PLANNING COMMISSION AGENDA

Planning Commission Meeting
6:00 PM Wednesday, December 2, 2020

RE: Case 20-21P, Final Development Plan for River Creek Lofts, 1771 Mason- Morrow- Millgrove Road

Summary of Review #1
River Creek Lofts Final PUD Plan
South Lebanon, Ohio

RECORD PLAT

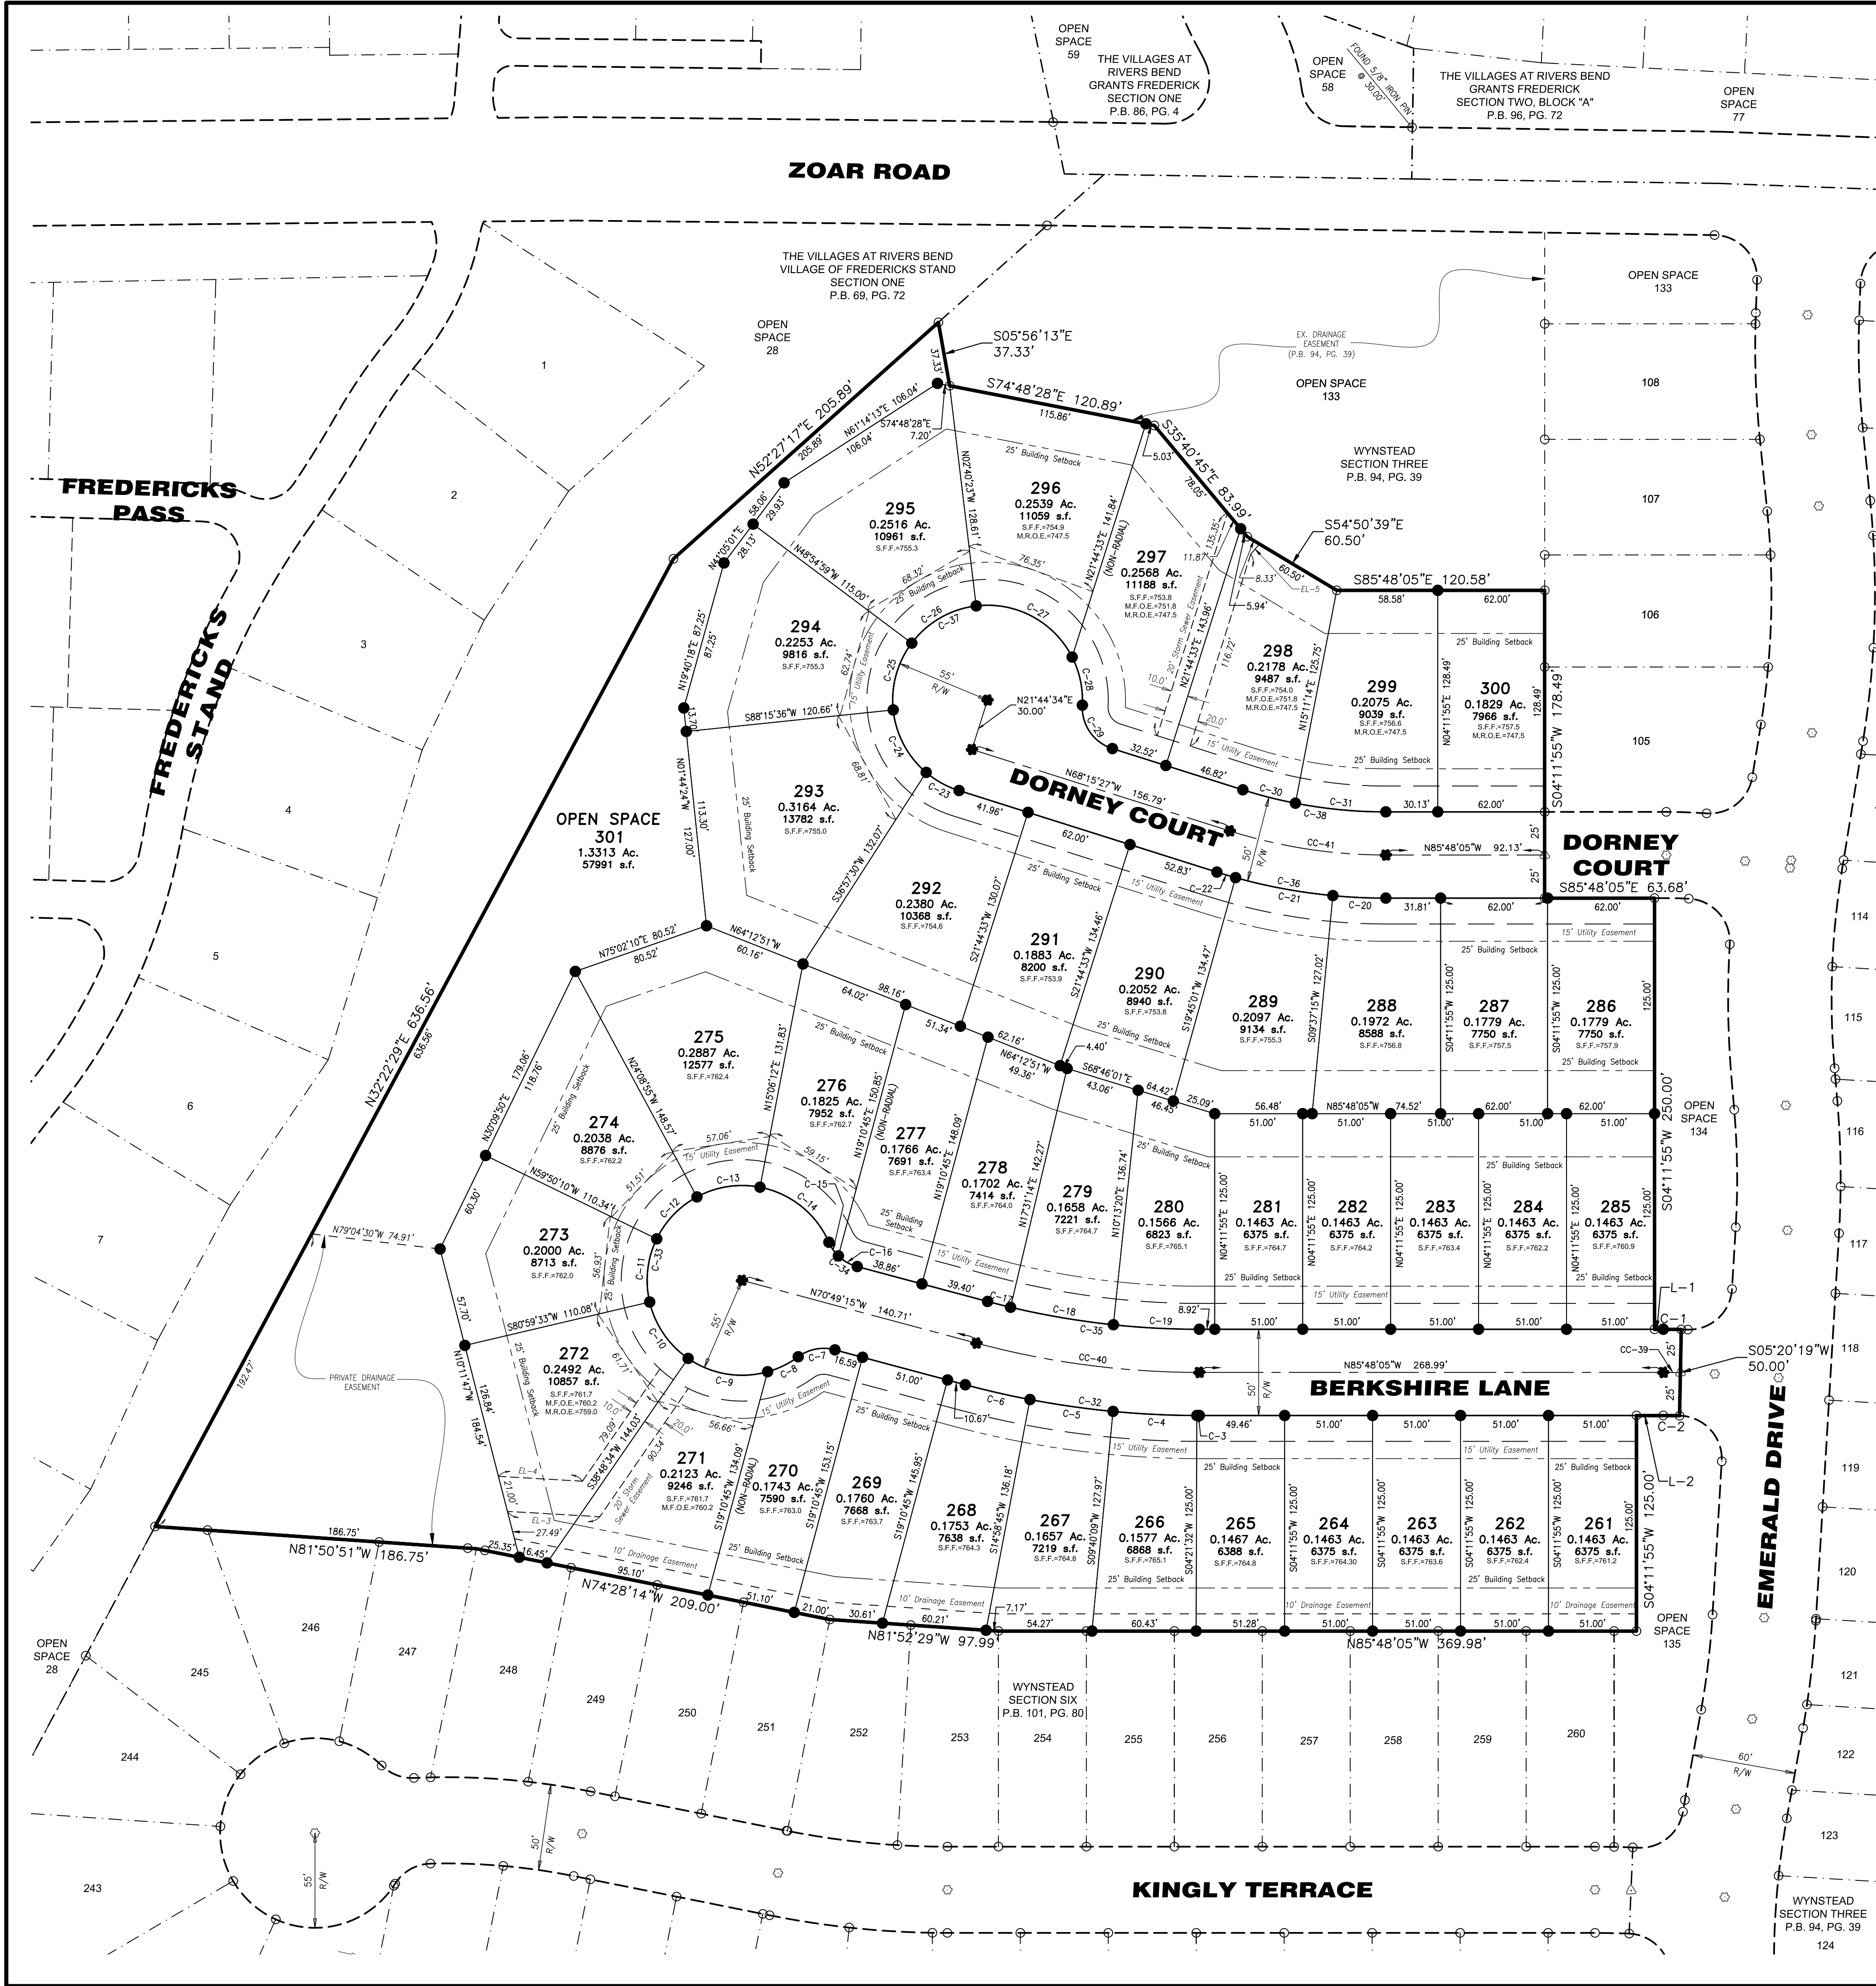
Development Name: Wynstead Section Seven
Reviewed By: C. Fluegeman –Choice One Engineering

c. Plat boundaries and closure	<input checked="" type="checkbox"/>	Boundaries are shown, just need copy of closure report for the boundary.
d. Bearings/distances to street lines	<input checked="" type="checkbox"/>

h. Lot numbers and lines	<input checked="" type="checkbox"/>	
i. Common areas	<input checked="" type="checkbox"/>	
j. Covenants and restrictions	<input checked="" type="checkbox"/>	Referenced on page 1 of the plat.
